**Economic Commission for Europe****Inland Transport Committee****World Forum for Harmonization of Vehicle Regulations****173rd session**

**1958 Agreement:****Consideration of draft amendments****to existing UN Regulations submitted by GRSP****Proposal for Supplement 3 to the 01 series of amendments to  
UN Regulation No. 129 (Enhanced Child Restraint Systems)****Submitted by the Working Party on Passive Safety\***

## Proposal for Supplement 3 to the 01 series of amendments to UN Regulation No. 129 (Enhanced Child Restraint Systems)

Figure 2

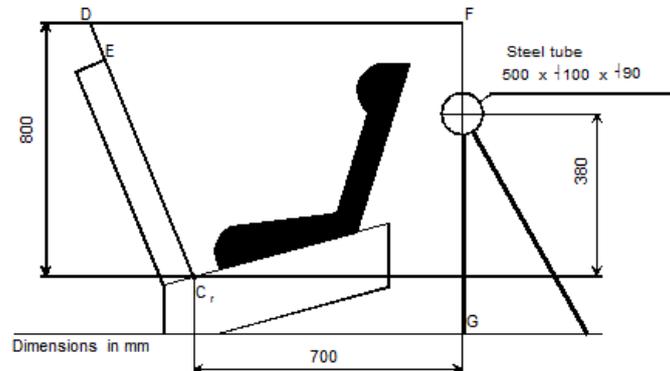
*Paragraph 6.6.4.1.2.1.*, amend to read:

"6.6.4.1.2.1. Head excursion: no part of the head of the dummy shall pass beyond the planes FD, FG and DE, as shown in Figure 2 below. This shall be judged up to 300 ms or the moment that the dummy has come to a definitive standstill whatever occurs first.

Except when testing using Q6 dummy where:

The value in relation to the FD plane is 840 mm.

Where a test is conducted with paragraph 6.6.4.1.6.2. or paragraph 6.6.4.1.8.2. above, only the second configuration test results without 100 mm diameter bar will be considered.

### **Method of defining head impact area of devices with backrests or impact shields and for rearward-facing devices defining the minimum size of side wings**

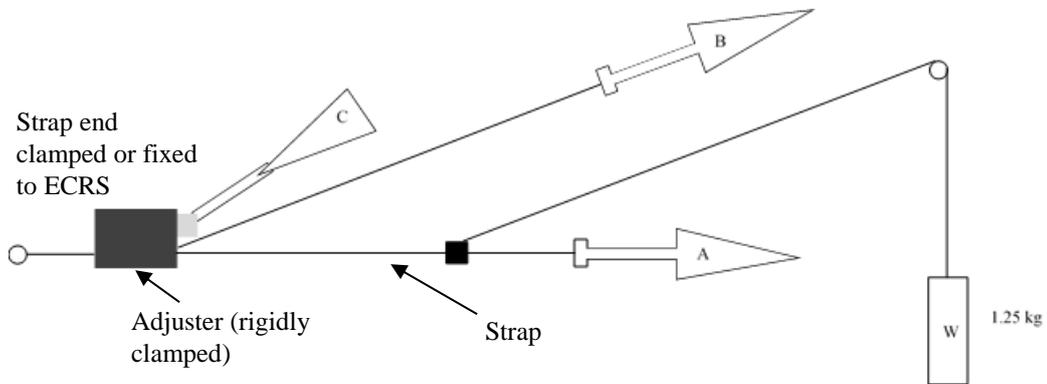
*Annex 14*, amend to read:

1. Head impact area
  - 1.1. Definition of backrest head impact area  
Place the device on the test bench described in...
  - 1.2. Definition of impact shield head impact area  
The impact shield head impact area is the whole upper surface of the impact shield, which comprises any surfaces visible from the top, looking down on the shield."

Figure 1.

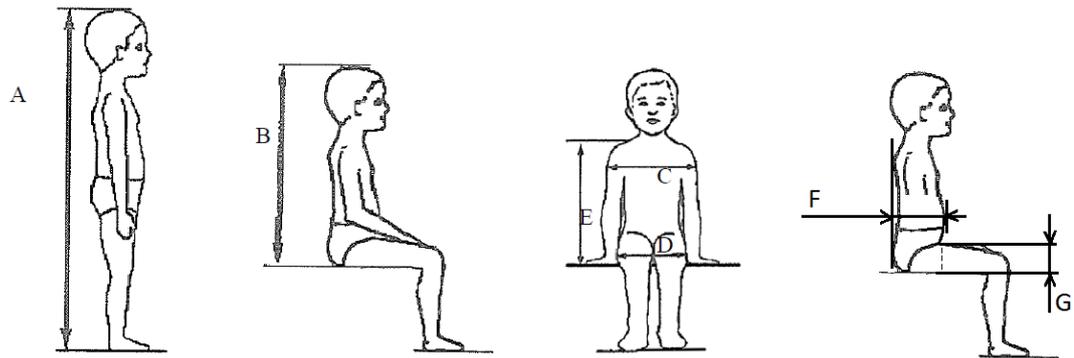
Annex 18, amend to read:

All lateral dimensions are measured under a contact force of 50 N with the devices described in Figure 2 and Figure 3 of this annex and the following tolerances will applied:

Figure 2  
ECRS Measurement Device - Side and Front View of the measuring device

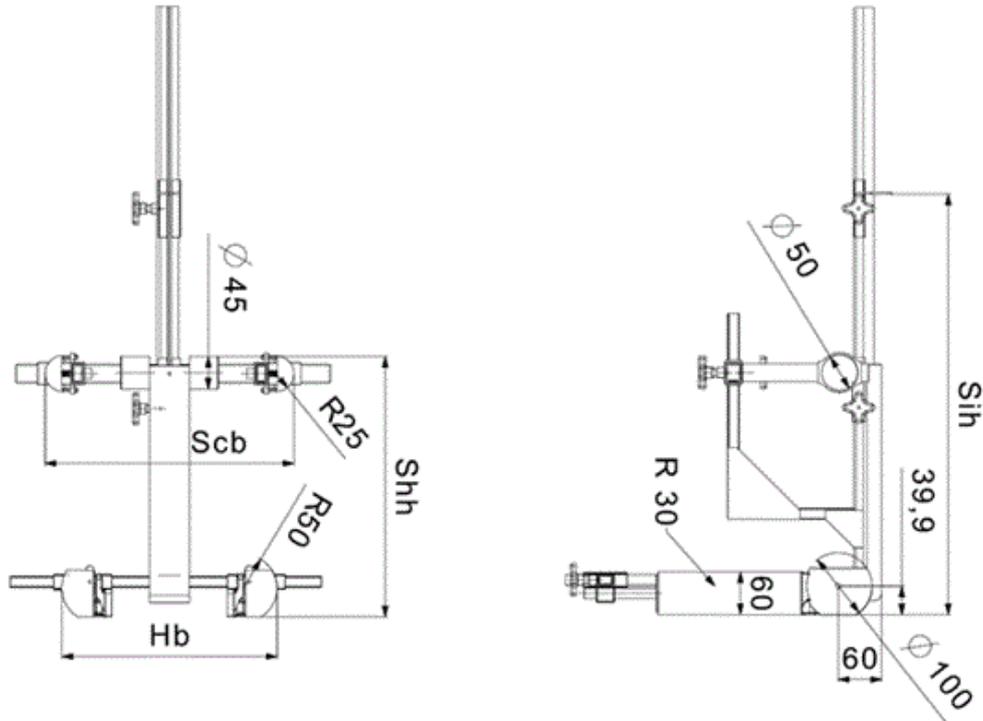
The mass of the devices described in Figure 2 and Figure 3 of this annex shall be 10 kg  $\pm$ 1 kg

For integral or non-integral ECRS the device shown in Annex 18, Figure 2 shall be used.

Figure 3  
**Side and Front View of the measuring device for measurements applicable to Enhanced Child Restraint Systems that feature an impact shield**

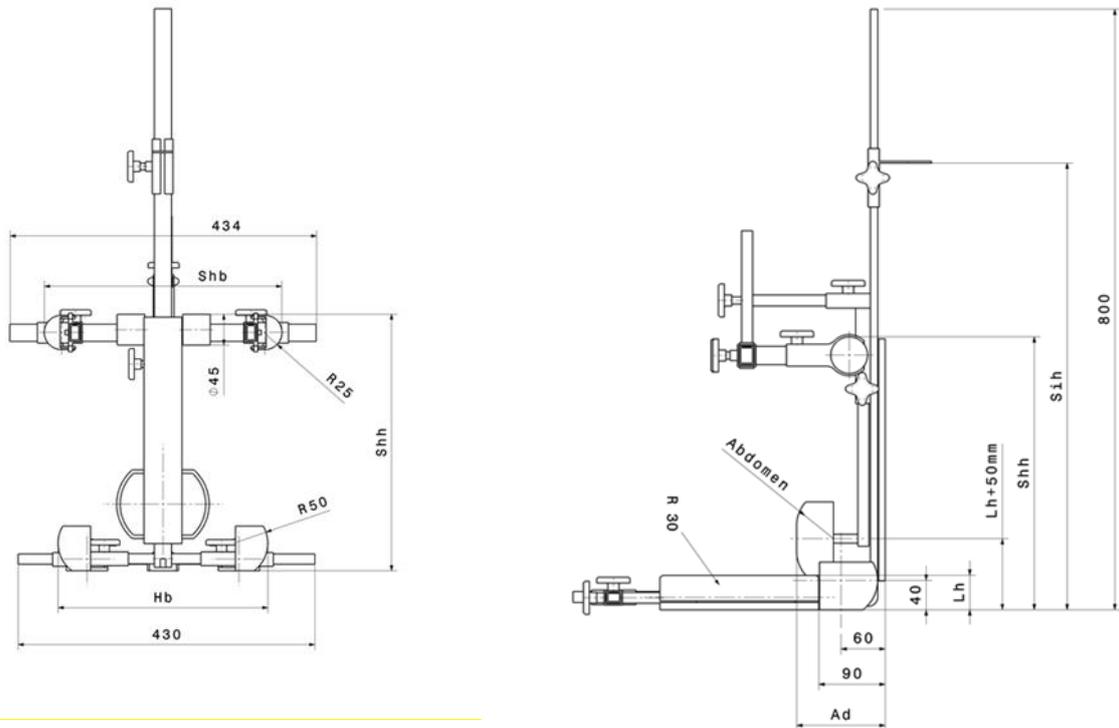
For ECRS with an impact shield the device shown in Annex 18, Figure 3 shall be used.
